Meeting Minutes Transmittal/Approval
Unit Managers Meeting: Grout Treatment Facility

Meeting Held June 26, 1991
Richland, Washington

Grout Treatment Facility
Unit Managers Meeting

Engineering Change Notices

**VAULT TEMPERATURE
THERMOCOUPLE PROBE
ASSEMBLY (TYP OF 4)**

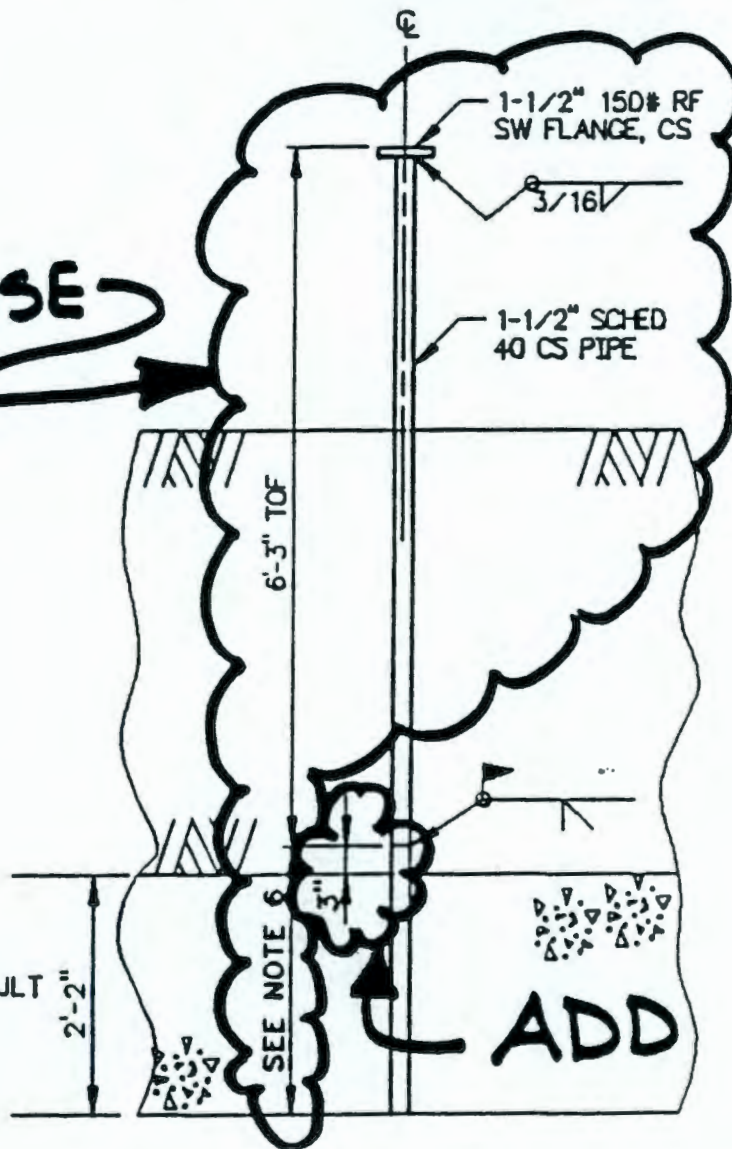
- A) DETAIL 3 (Z E4): Extend riser as shown on page 8 of this ECN.
- B) SECTION A (Z C6): Modify probe assy as shown on page 9 of this ECN.
- C) NOTE 6: Change to read as follows -
RISER #42 AND #45 MEASURED FROM BOTTOM OF CORBEL. LENGTH = 2'-11" WITH 3" EXTENSION ABOVE ROOF PANEL. RISER #43 AND #44 LENGTH = 2'-5" WITH 3" EXTENSION.

- A) DETAIL 3 (Z E4): Extend riser as shown on page 8 of this ECN.
- B) SECTION A (Z C6): Modify probe assy as shown on page 9 of this ECN.
- C) NOTE 6: Change to read as follows -
RISER #42 AND #45 MEASURED FROM BOTTOM OF CORBEL. LENGTH = 2'-11" WITH 3" EXTENSION ABOVE ROOF PANEL. RISER #43 AND #44 LENGTH = 2'-5" WITH 3" EXTENSION.

Ref. Dwg.	Sh.	Rev.	Prepared By	Checked By	ECN No.	Page
H-2-77620	1	0	GF MCKEE	PC BARROWS	B-714-84	10/11
H-2-78492	1	0

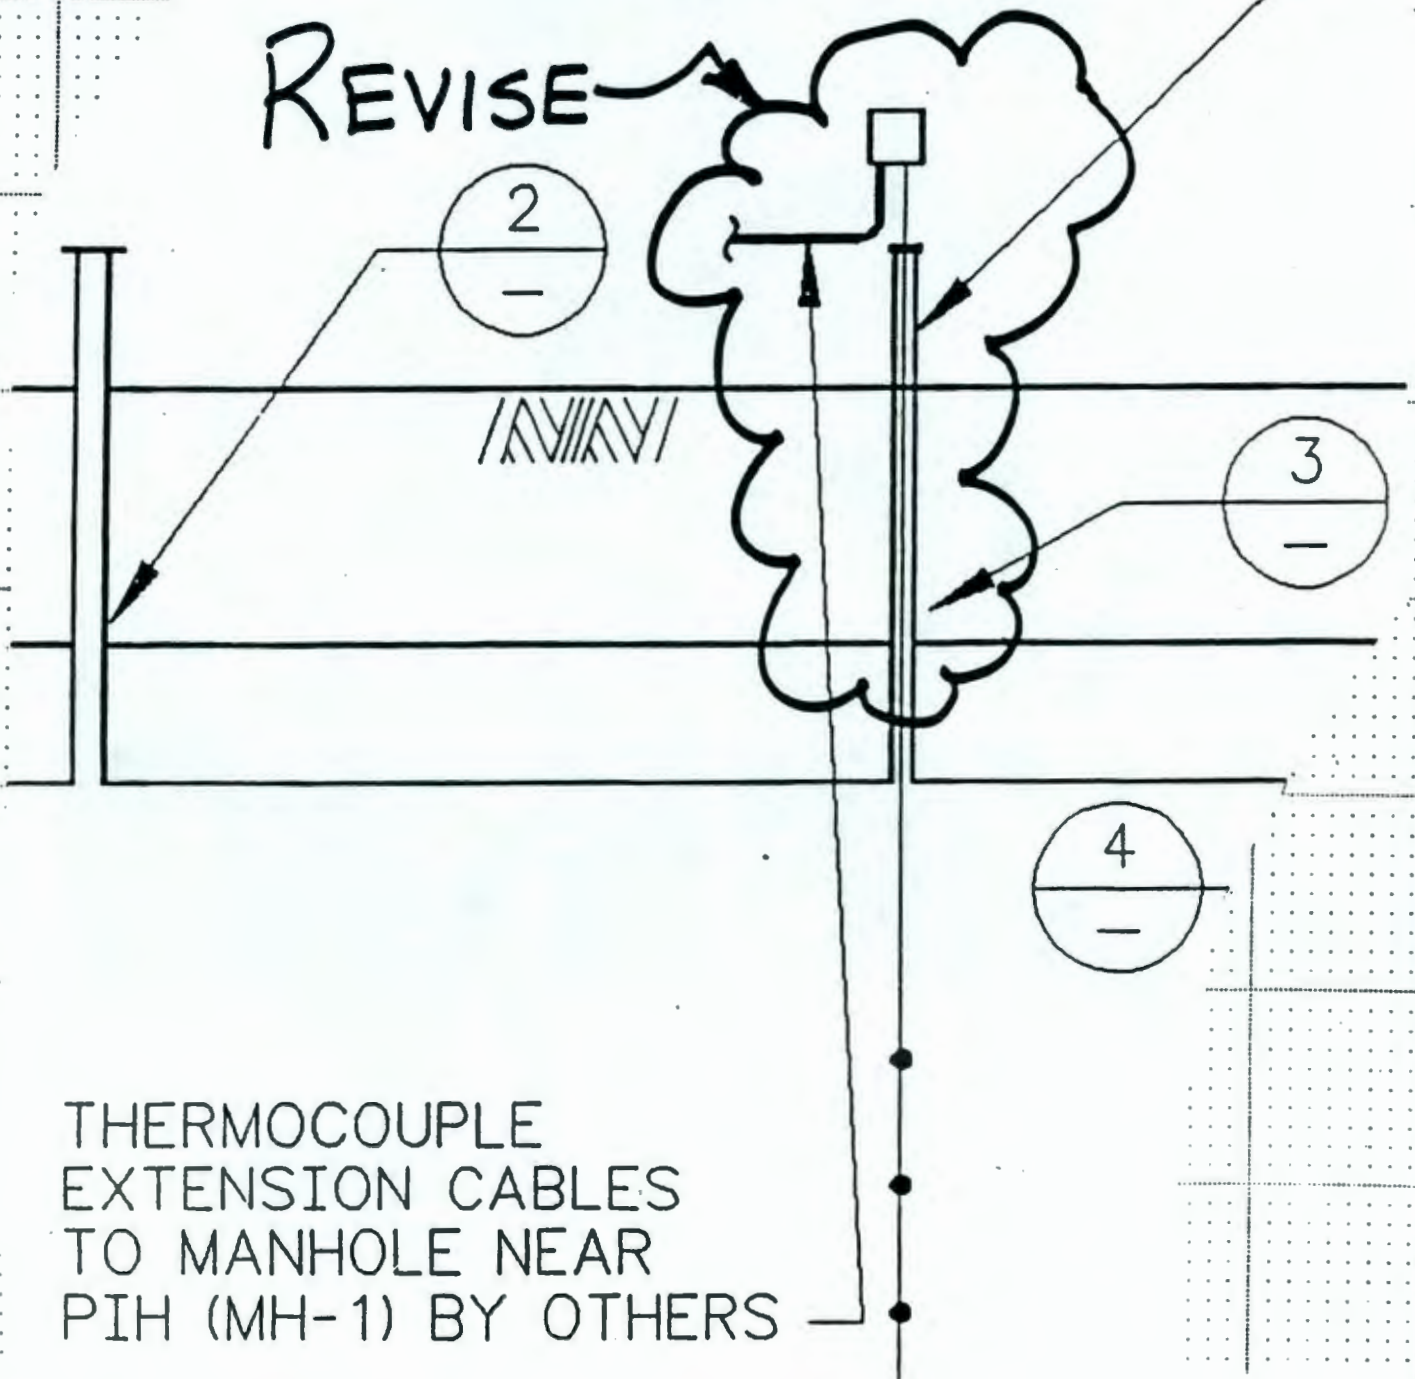
- A) ASSEMBLY (Z E4-F5, C4):
 - 1. Change junction box to pull box as shown on page 10 of this ECN.
 - 2. Change PROBE INSERTION LENGTH to read 43'-6".
- B) Change Note 3 to read THERMOCOUPLE ASSEMBLIES AS SUPPLIED BY VENDOR SHALL HAVE PROTECTION TUBE. THERMOCOUPLE PULL BOX SHALL BE SUITABLE FOR BURIAL.
- C) DELETE Note 6 in its entirety.

- A) ASSEMBLY (Z E4-F5, C4):
 - 1. Change junction box to pull box as shown on page 10 of this ECN.
 - 2. Change PROBE INSERTION LENGTH to read 43'-6".
- B) Change Note 3 to read THERMOCOUPLE ASSEMBLIES AS SUPPLIED BY VENDOR SHALL HAVE PROTECTION TUBE. THERMOCOUPLE PULL BOX SHALL BE SUITABLE FOR BURIAL.
- C) DELETE Note 6 in its entirety.

Ref. Dwg.	Sh.	Rev.	Prepared By	Checked By	ECN No.	Page
H-2-77620	2	1	GF MCKEE	PC BARROWS	B-714-84	11/11
H-2-78492	2	1

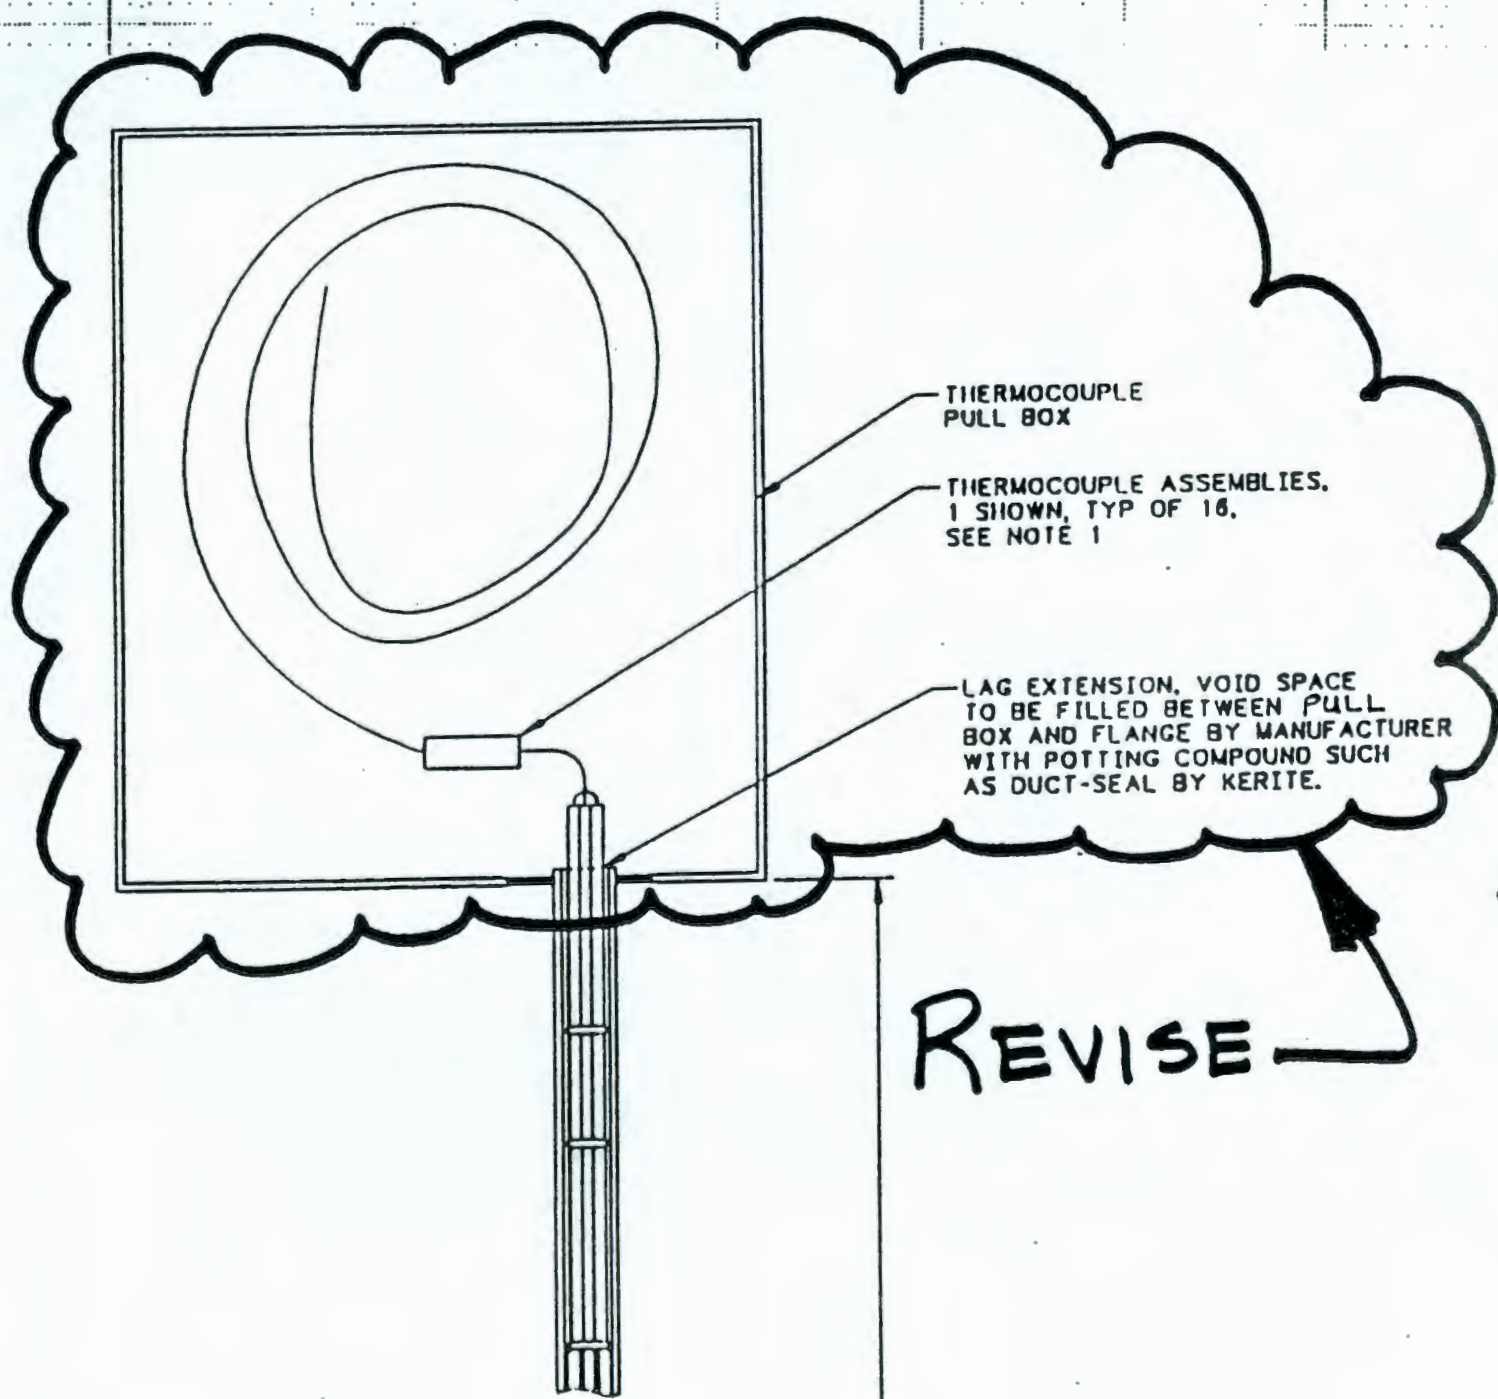
- A) ASSEMBLY (Z E4-F5, C4):
 - 1. Change junction box to pull box as shown on page 11 of this ECN.
 - 2. Change PROBE INSERTION LENGTH to read 43'-6".

- A) ASSEMBLY (Z E4-F5, C4):
 - 1. Change junction box to pull box as shown on page 11 of this ECN.
 - 2. Change PROBE INSERTION LENGTH to read 43'-6".

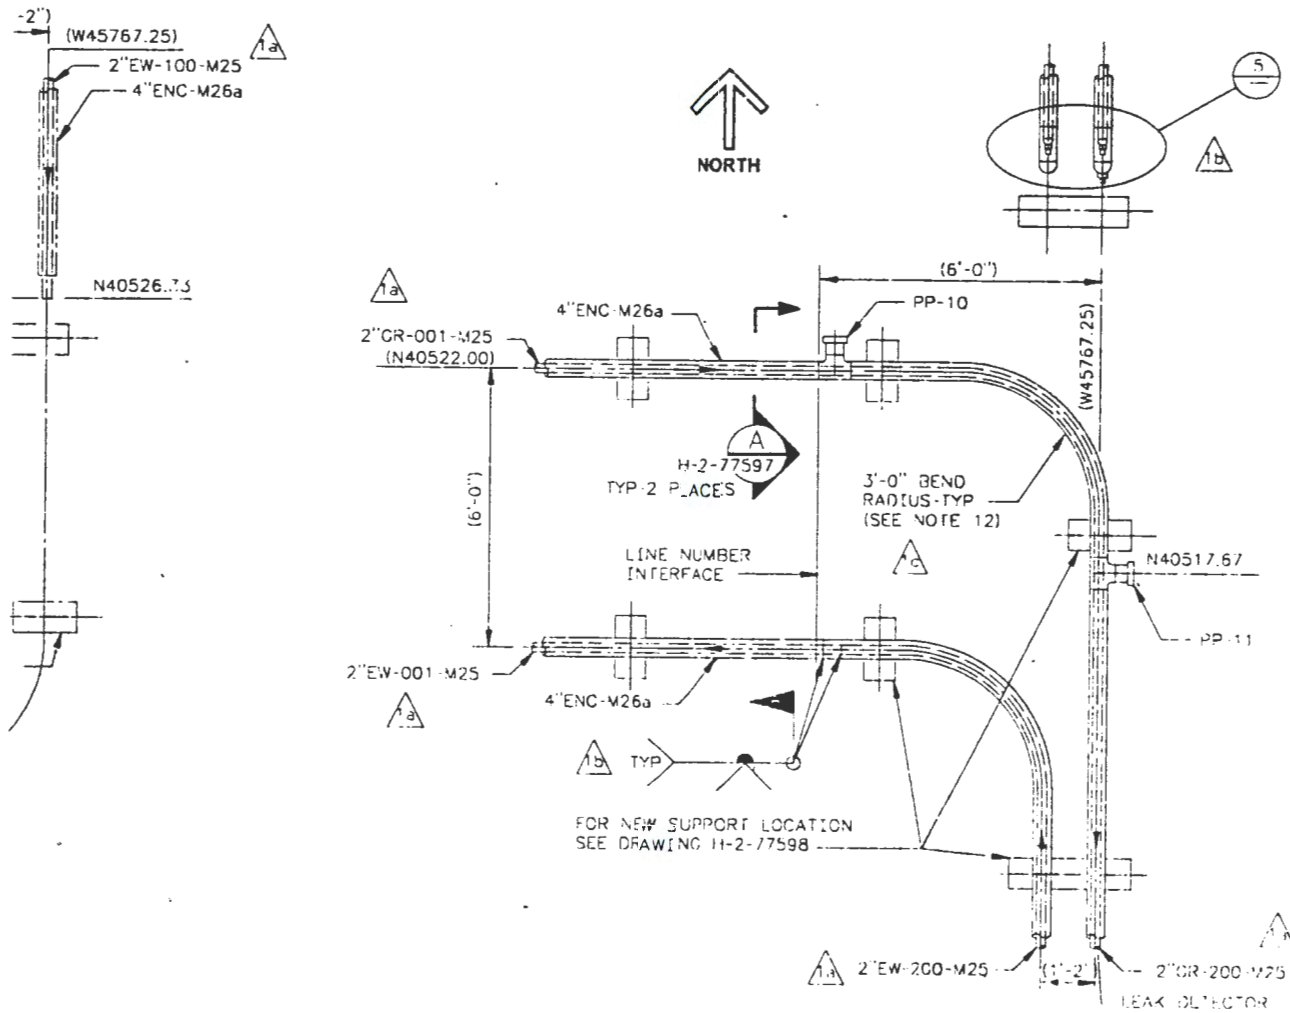
REMOVE PIPING IN
 THIS AREA AS SHOWN

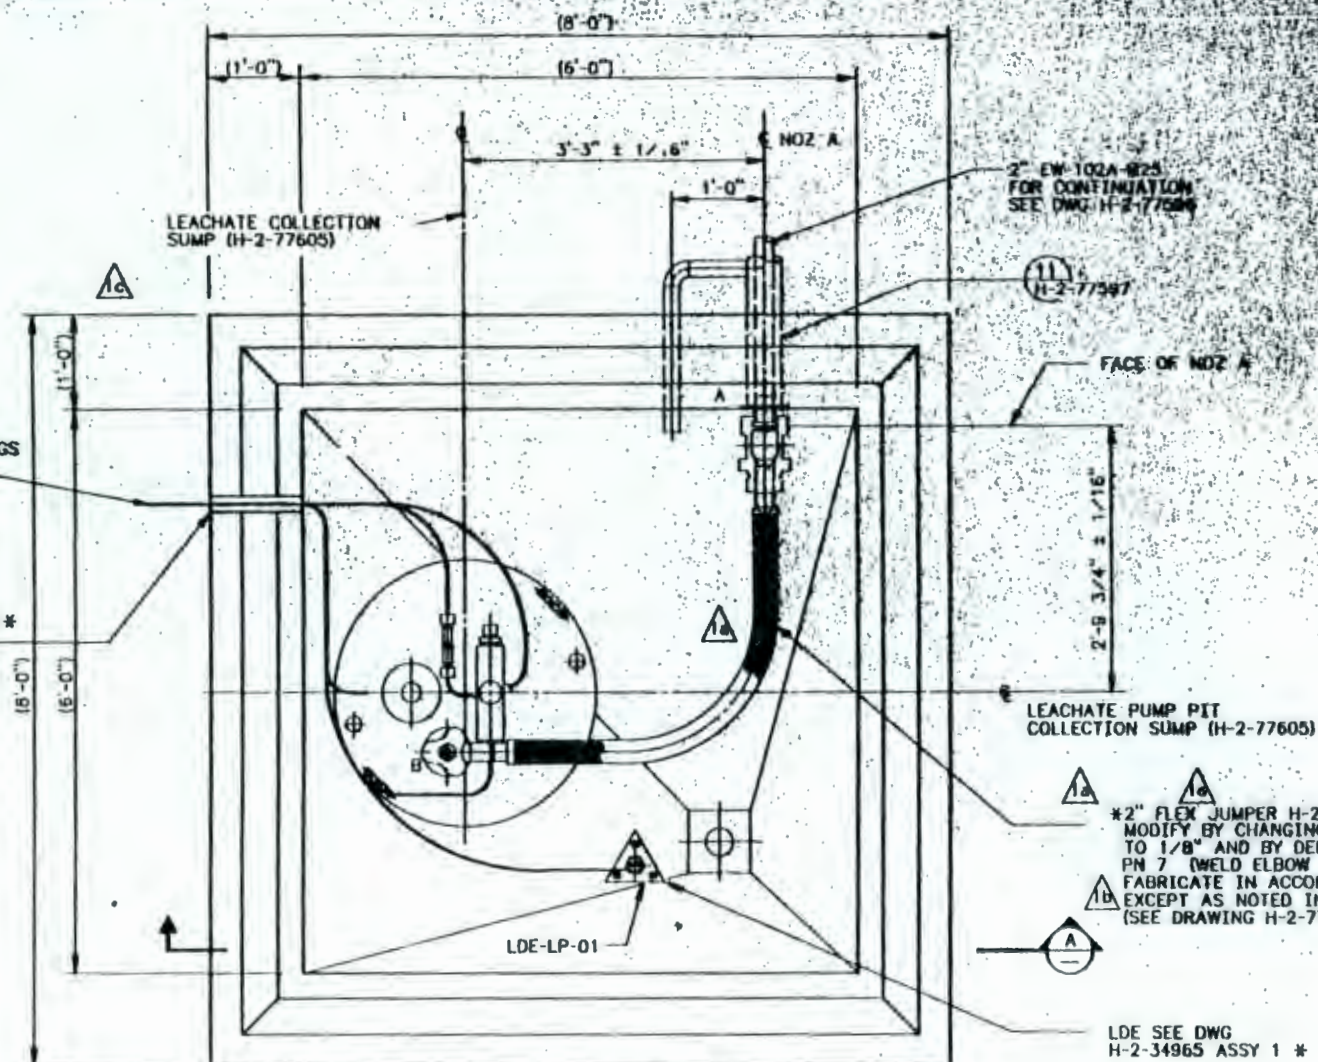
2 SEAL CABLE SLOT **
SEE NOTE 2

1a *2" FLEX JUMPER H-2-96872/3-6-2H-1-2V
MODIFY BY CHANGING FILLET WELD SIZE
TO 1/8" AND BY DELETING PN 18 FROM CONN
PN 7 (WELD ELBOW TO PN 7)
1b FABRICATE IN ACCORDANCE WITH HS-85-0084
EXCEPT AS NOTED IN SPECIFICATIONS
(SEE DRAWING H-2-77603 SH 2)
